ISO 11439

AMENDMENT 1
2021-10

Gas cylinders — High pressure cylinders for the on-board storage of natural gas as a fuel for automotive vehicles

Reference number
ISO 11439:2013/Amd.1:2021(E)

Figure H.1 — Accelerated cyclic corrosion flow diagram

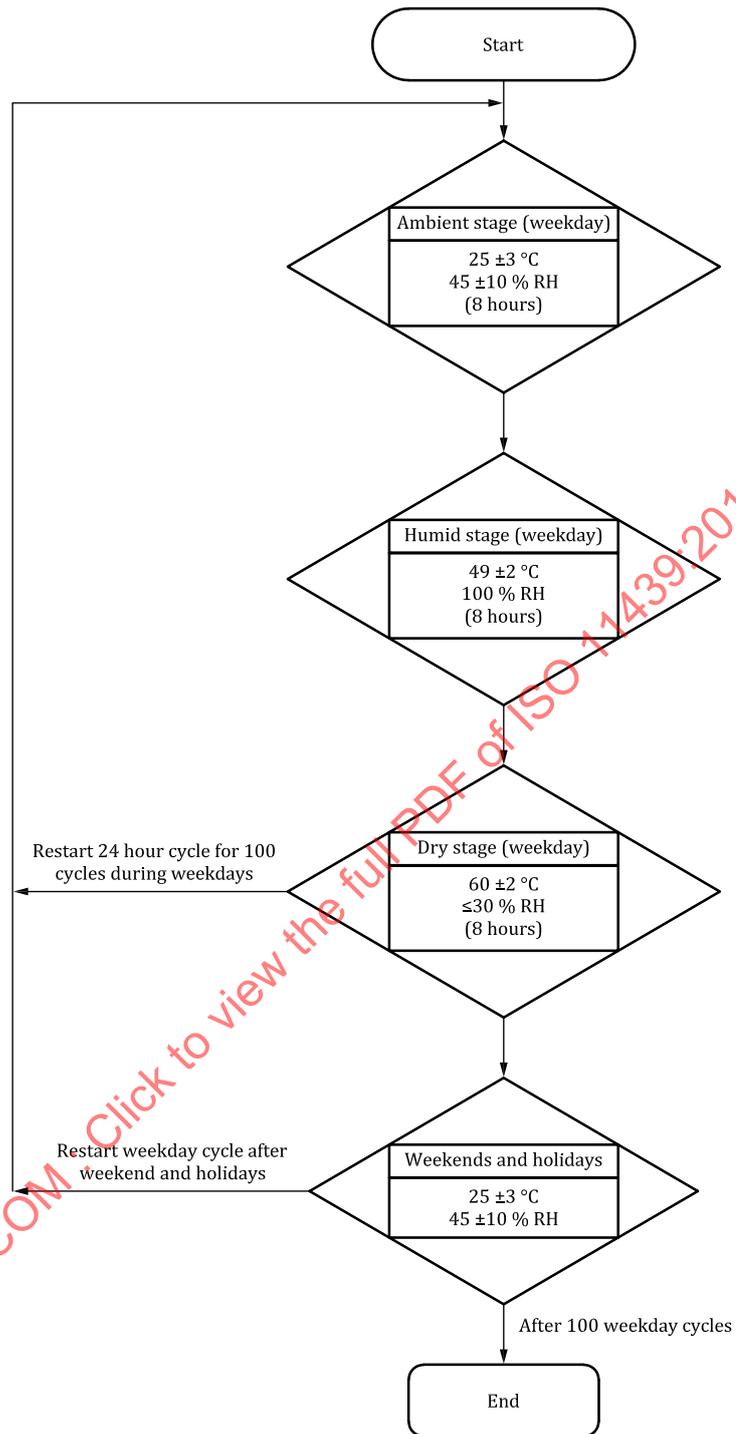
Add a new annex at the end of Annex G as follows:

The test method involves 1 % (approximate) complex salt mist applications coupled with high temperature, high humidity and high temperature dry off. One test cycle is equal to 24 h, as illustrated in Figure H.1.
